5. Additional investigations undertaken after exhibition of the Environmental Assessment

5.2 Glenfield flyover at Leacock Regional Park and Throsby Park

6. Modifications to the proposal

Figure 5.2 Glenfield flyover: refined proposal

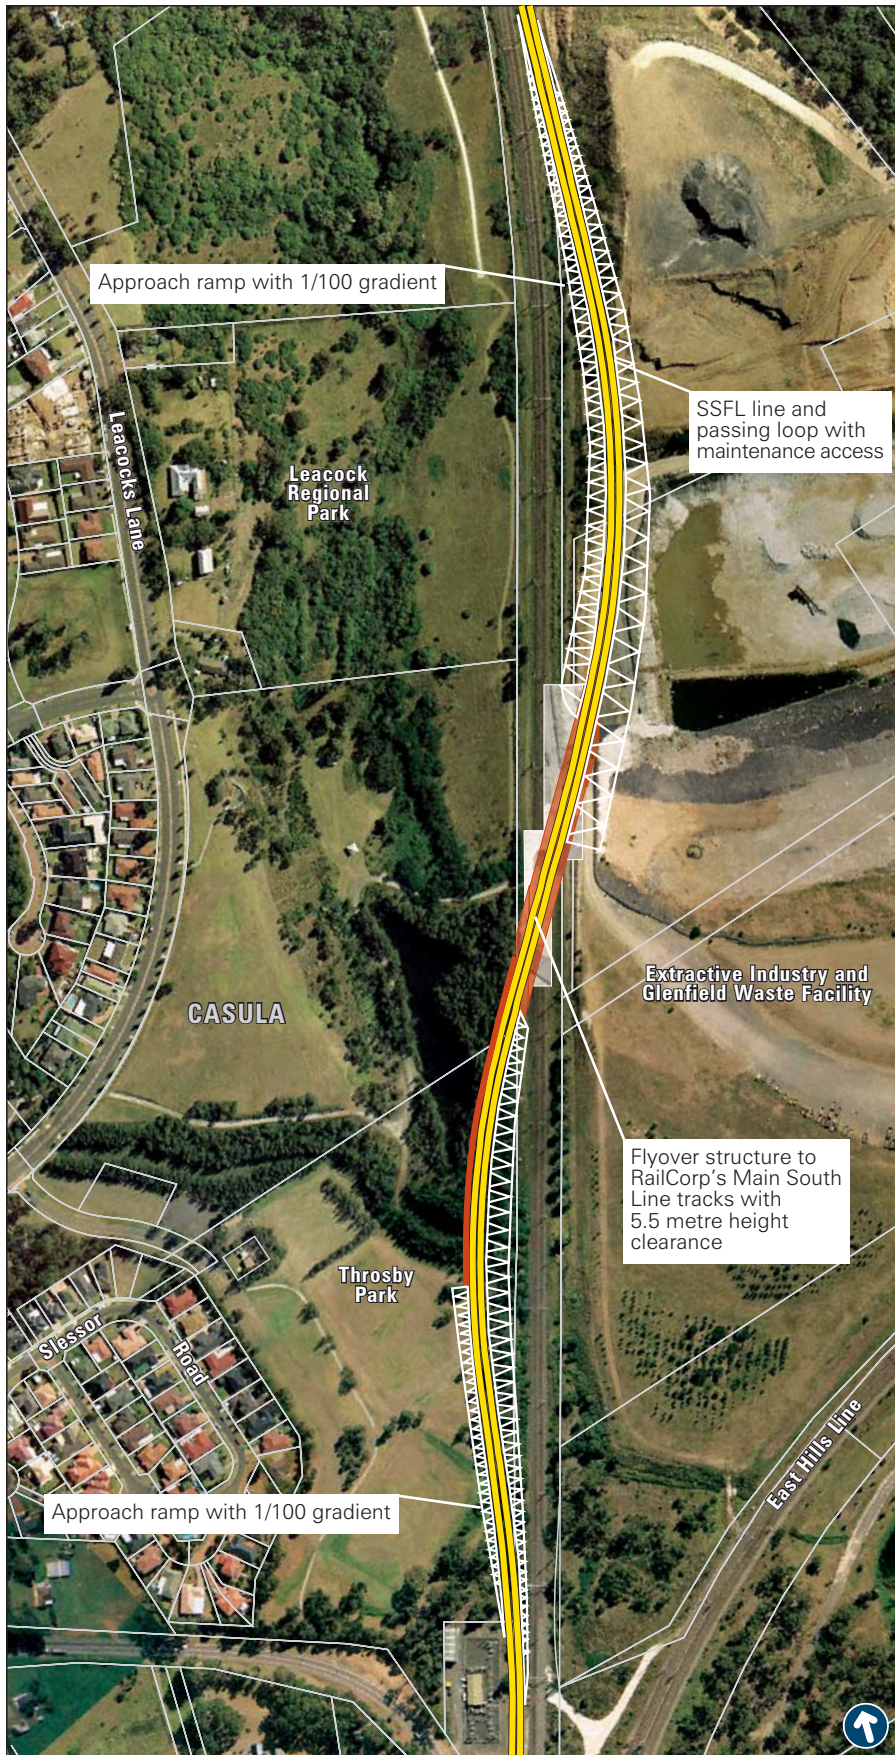
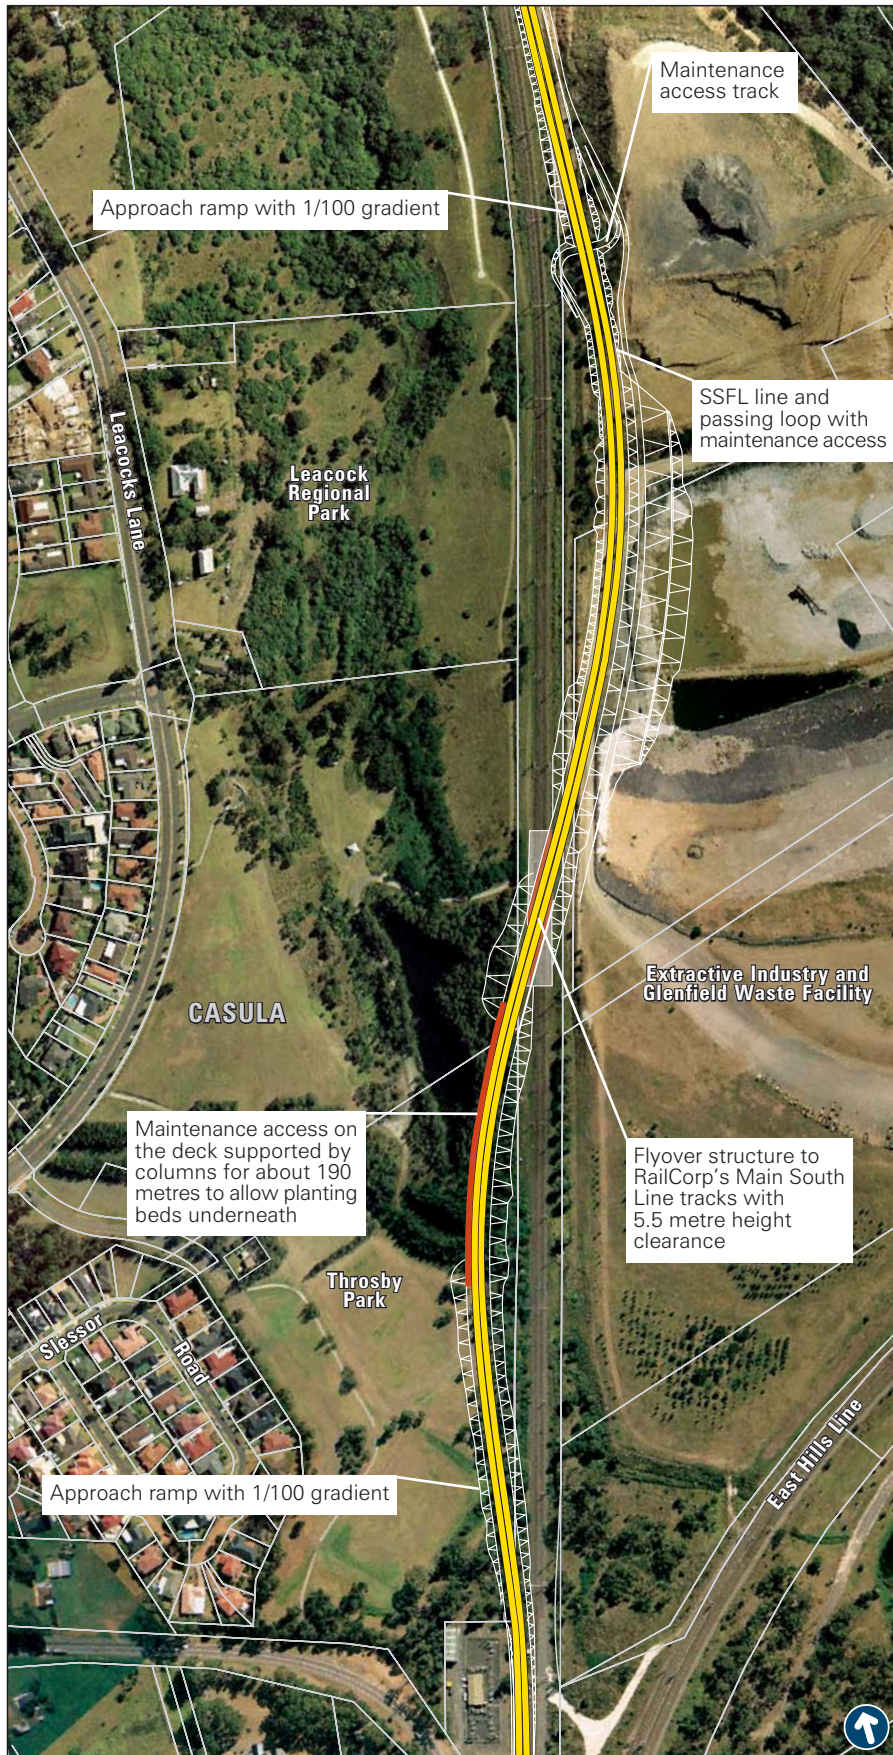
As part of undertaking these further investigations at Leacock Regional Park and Throsby Park, the proposed concept design for the Glenfield flyover has been refined in the following ways (see also *Figure 5.2*):

- The third track that was catered for in the current proposal (the potential future Down relief freight track on the eastern side of the rail corridor) has been deleted (with the agreement of RailCorp) and therefore the flyover does not need to allow for its future provision. This means the size of the bridge deck units is reduced by half (given that the span only needs to cross the existing two RailCorp tracks) and the retaining wall for the northern approach ramp has moved closer to the rail corridor.

- The retaining wall located adjacent to the pond (un-named) in Throsby Park, is proposed to be refined with a retaining wall and landscape treatment to address the pond edge. The maintenance access track adjacent to the SSFL track would be on a deck supported by columns at five metre centres allowing for planting beds underneath. The north westerly orientation and height clearance to the deck above would allow for sun exposure. This new planting area would extend approximately 190 metres.

- The embankment for the northern approach ramp has been widened due to the lower than anticipated excavated ground level on the Glenfield Waste Facility land.

- The retaining wall located in Leacock Regional Park near the southern approach ramp has been refined with a revegetated batter that would contribute to visual screening of the flyover.

Figure 5.5 Glenfield flyover: proposed landscape concept plan

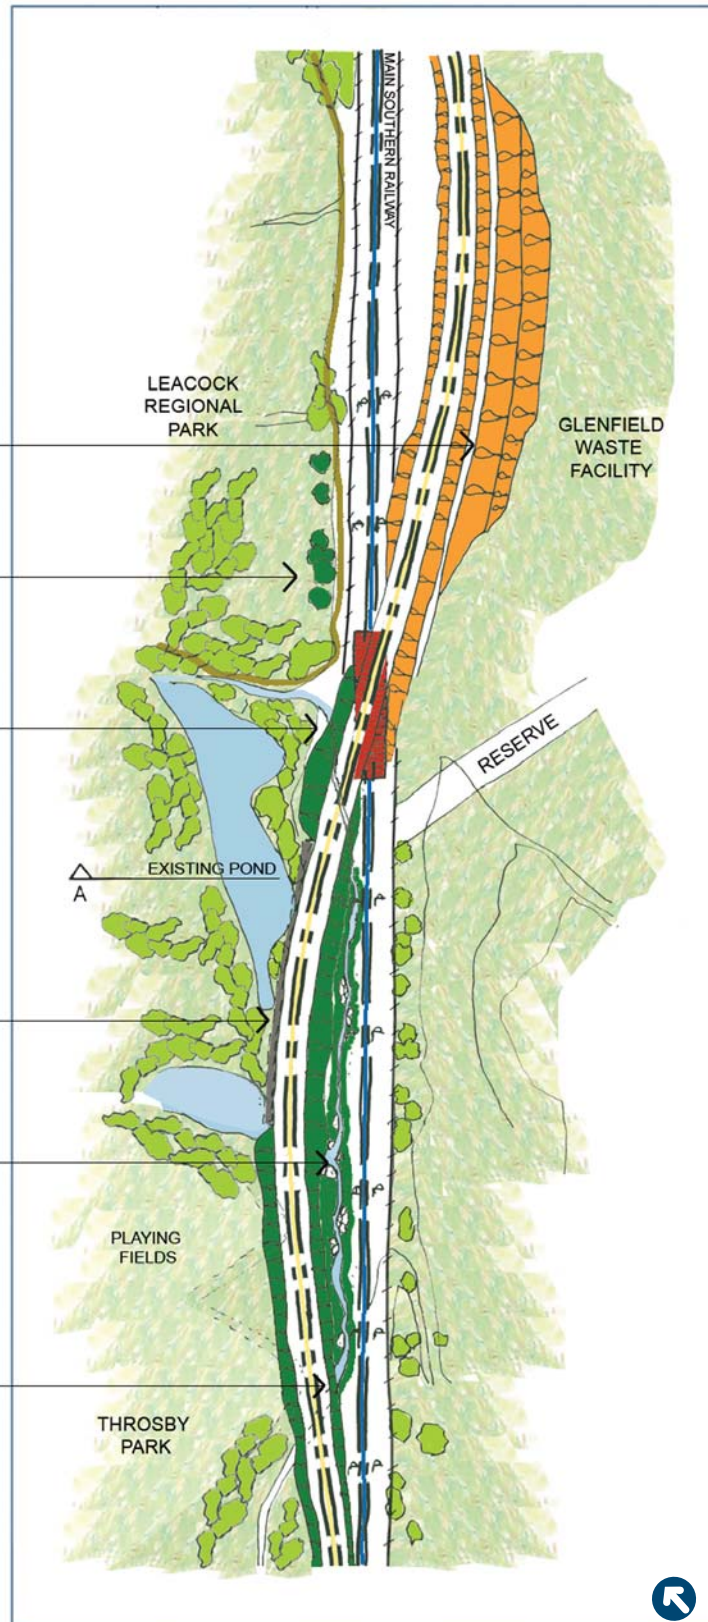
- Embankments: where space allows batters would be constructed to a gradient of 2:3, which is compatible for revegetation. Steeper batters may be needed adjacent to the playing fields in Throsby Park.
- Topsoil: any clearing in the vicinity of the Cumberland Plain Woodland would include the retention of the topsoil layer, with its latent seed bank, for re-use in the area
- Planting species: species would be selected to revegetate the proposed batters based on their compatibility with the Cumberland Plain Woodland (e.g. *Casuarina glauca*, *Melaleuca linarrifolia*).

- Terraces: the eastern side of the northern approach ramp is adjacent to the Glenfield Waste Facility and requires more extensive battered slopes, which would take form as two to three temporary battered terraces. The two lower tiers would be stabilised with grasses before being submerged below the tips finished ground layer.

- Railway corridor edge: the western side of the railway corridor has an intermittent line of trees at its park edge. This visual screen would be augmented by additional trees, for example, *Casuarina glauca* or *Casuarina cunninghamiana*.

- Pond edge: the southern approach ramp of the flyover would incorporate a design to address the pond edges, which would be adjacent to the structure. The maintenance access track adjacent to the SSFL and passing loop tracks would be on a deck supported by columns at five metre centres, allowing for planting beds underneath (refer Section A in *Figure 5.5*). The north western aspect of the colonnaded planting bed would allow for sun exposure. Rainwater from the flyover would be channelled to the planting beds below.

- Re-aligned drainage gully: the existing drainage gully would be re-aligned to cross the SSFL and lie between it and the RailCorp corridor. The drainage gully will be terraced with rocks and regulated to encourage a water flow resembling the principles of a natural creek, avoiding concrete elements and the rail corridor.

Figure 6.2 Leightonfield Yard: modified proposal

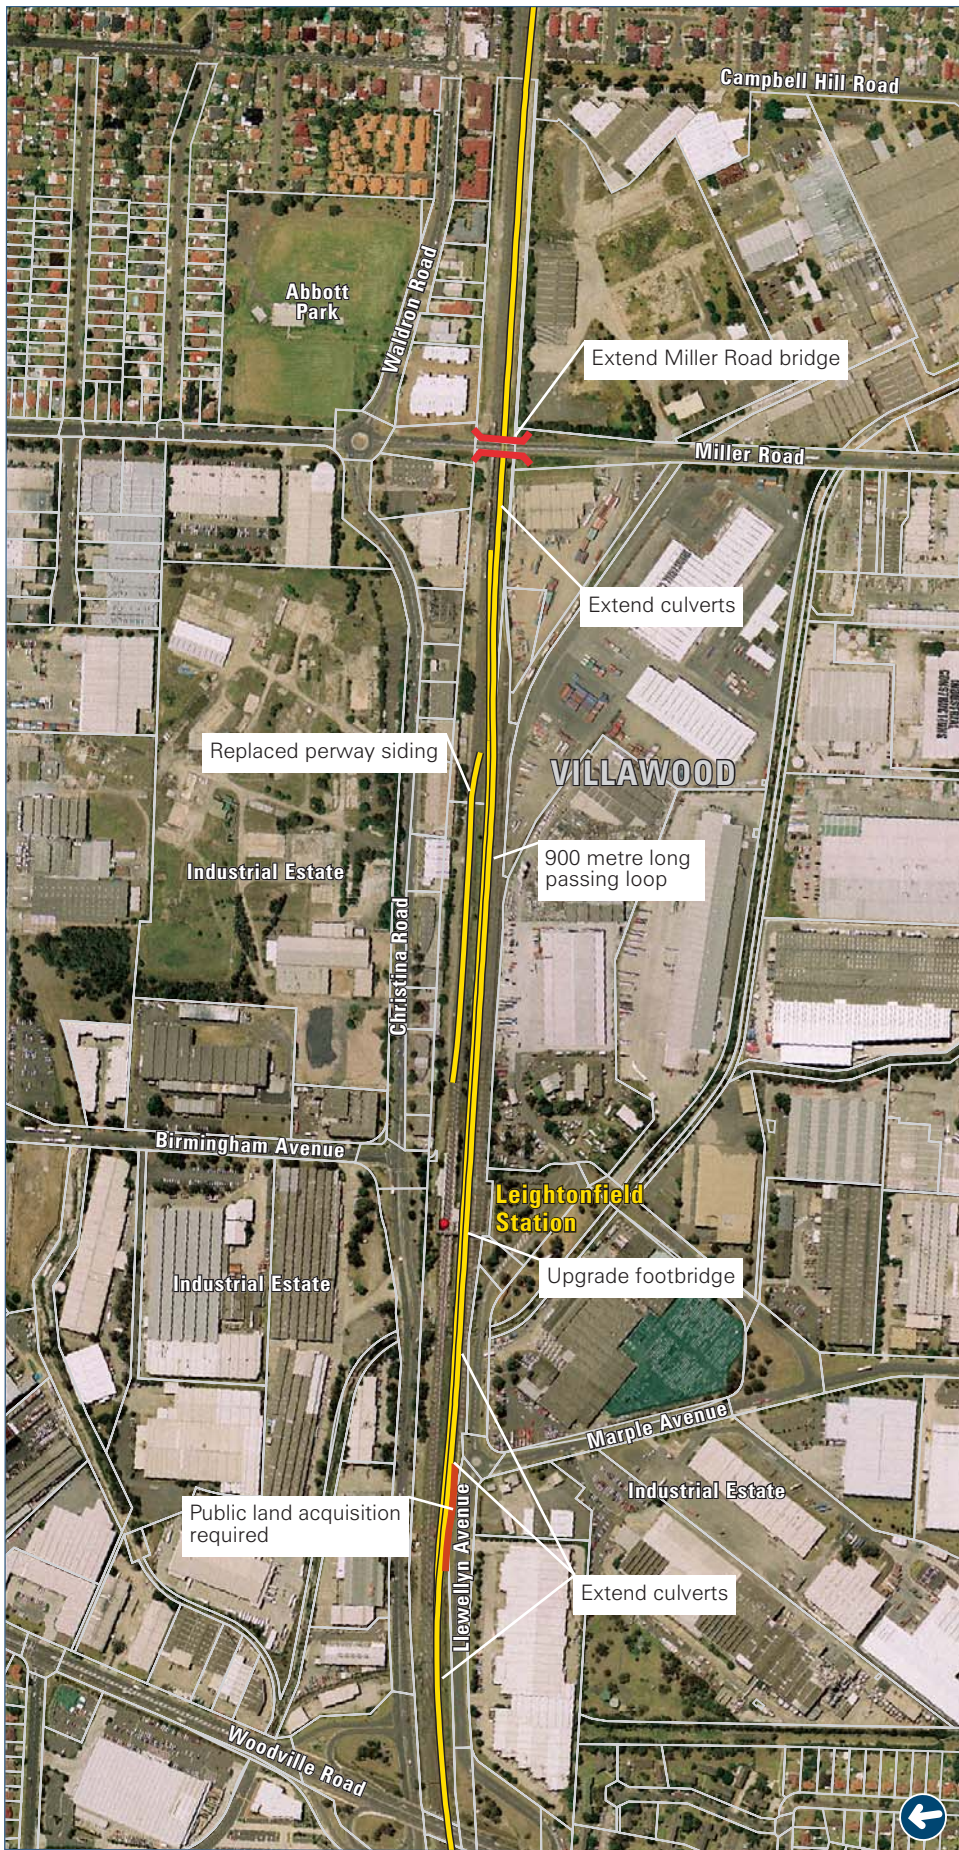
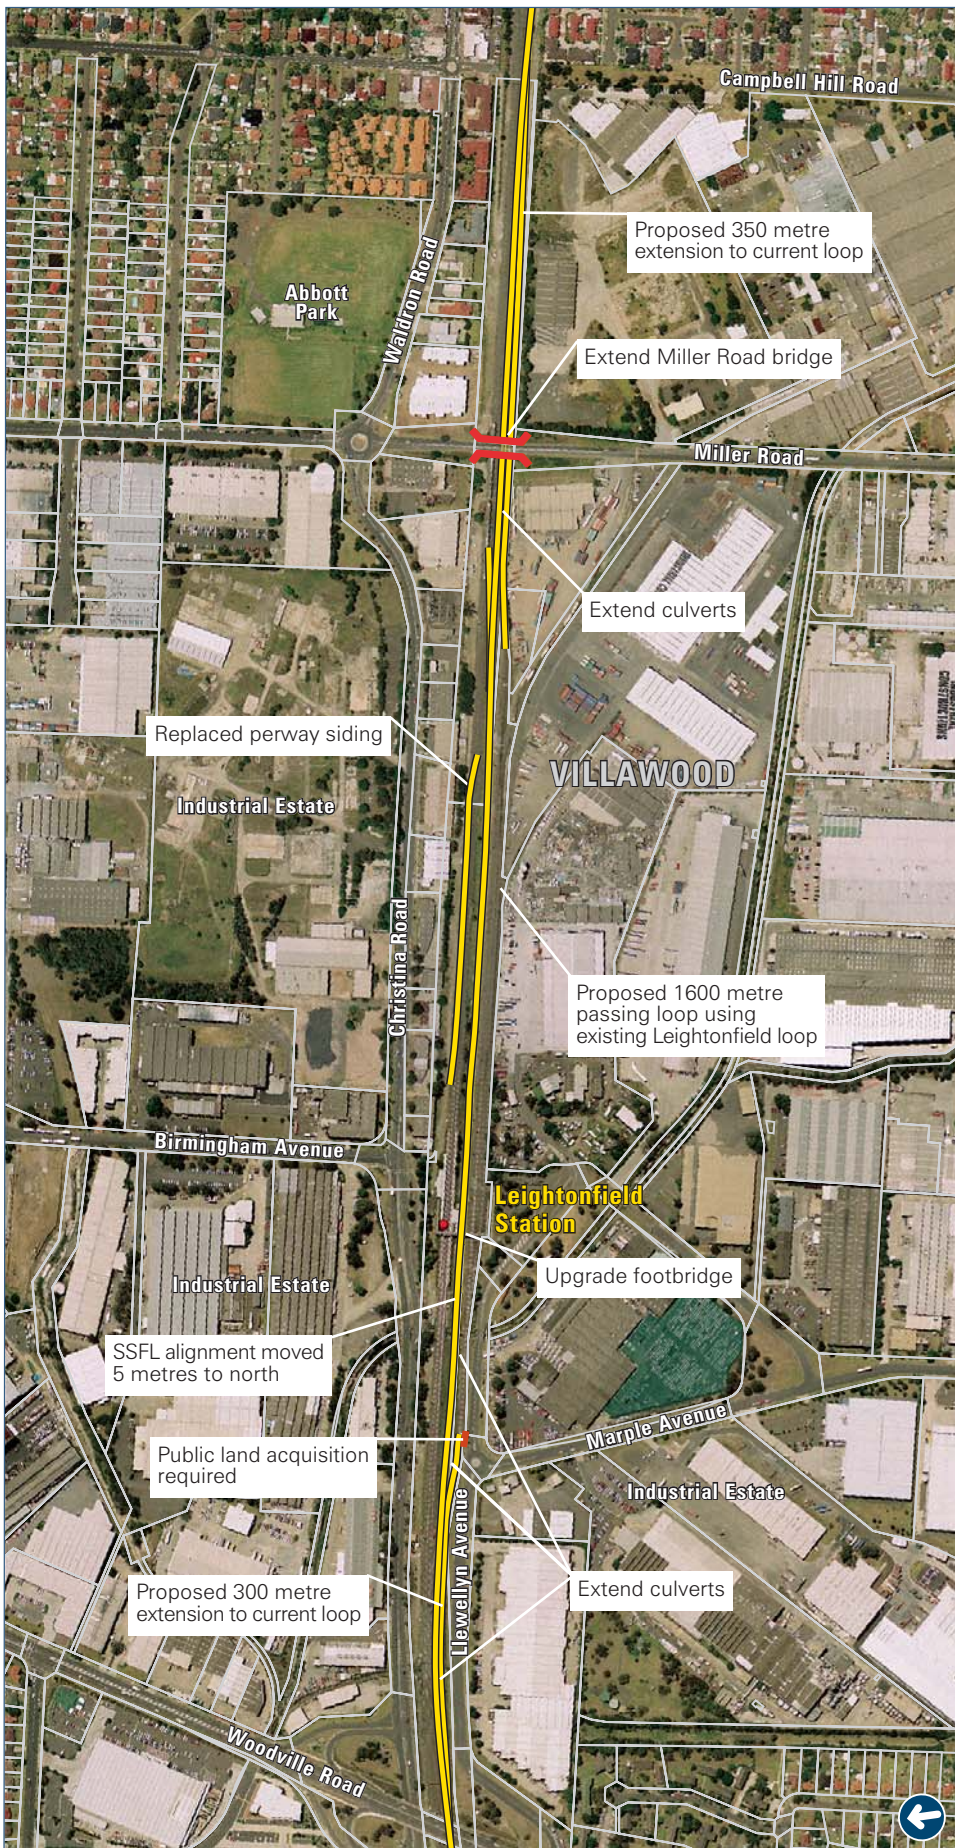
The previously proposed 900 metre crossing loop is to be deleted from the concept design. As a consequence, the alignment of the SSFL is modified and located approximately five metres further to the north within the rail corridor, but still within the space available between the RailCorp tracks and the Leightonfield sidings.

The former crossing loop is to be replaced by a proposed 1,600 metre long passing loop with standing room to accommodate a 1,500 metre freight train. The proposed passing loop would be created by connecting and extending the existing Leightonfield Yard loop. The additional loop length is created by approximately 300 metres of new track to the west and approximately 350 metres of new track to the east. The location of the proposed passing loop is shown on *Figure 6.2*. The proposed acquisition of the Llewellyn Avenue road reserve would reduce to about four metres in width (at the widest point due to an irregular boundary) at the Marple Avenue intersection.
